**Subject: CD Changer, Noise (Alternator Whine) Can Be Heard
With Rear Defogger Switched ON**

Number: 01-01

Model(s): TT Coupe

Date: Jan. 8, 2001

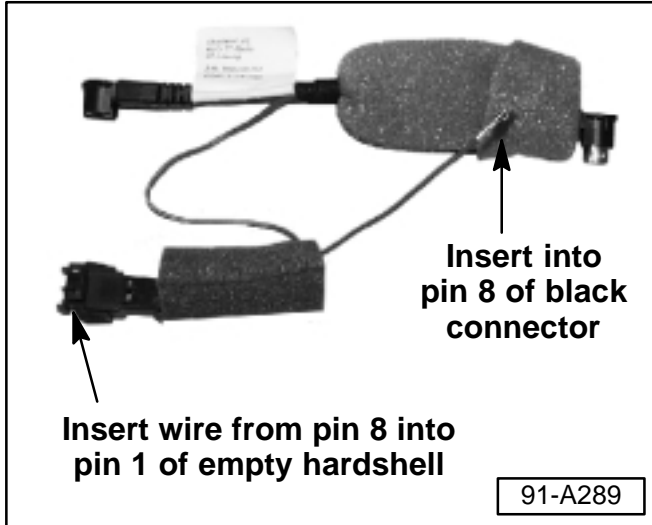
◀ Install Part No: 8N0 035 550A (adapter harness) to radio as follows:

- Remove Radio (see *Radio, removing and installing* in Group 91 *Radio, Telephone, Navigation, Trip Computer* of Repair Manual CD ROM).

◀ - Remove antenna cable from radio.

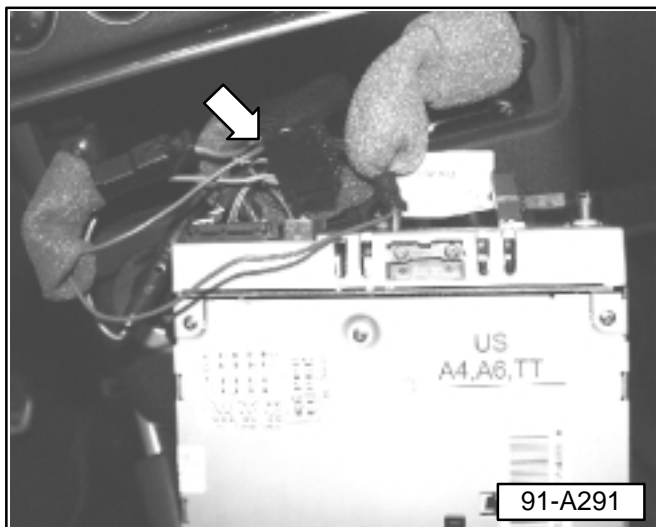
- Insert adapter harness antenna lead into radio.
- Connect antenna lead to adapter harness.
- ◀ - Remove black multi-wire connector from radio.
- Remove wire from cavity 8 on black multi-wire connector (use appropriate tool from VAS 1978 wiring harness repair kit).

- ◀ - Insert wire terminal from adapter harness into cavity 8 of black multi-wire connector.
- Separate empty black two-pin hard-shell connector from adapter harness.
- Insert wire (from cavity 8) into cavity 1 of empty two pin connector and close connector shell.
- Reconnect two pin hard-shell (with wire in cavity 1) to adapter harness.
- Reconnect black multi-wire connector into radio.
- Slide anti-rattle foam over hard-shell connections (prevents rattles).
- Carefully reinstall radio (locate adapter harness to prevent rattling).
- Code radio if necessary, see Code Control Module (function 07) in Group 01 - *Radio system, On Board Diagnostic (OBD)*.
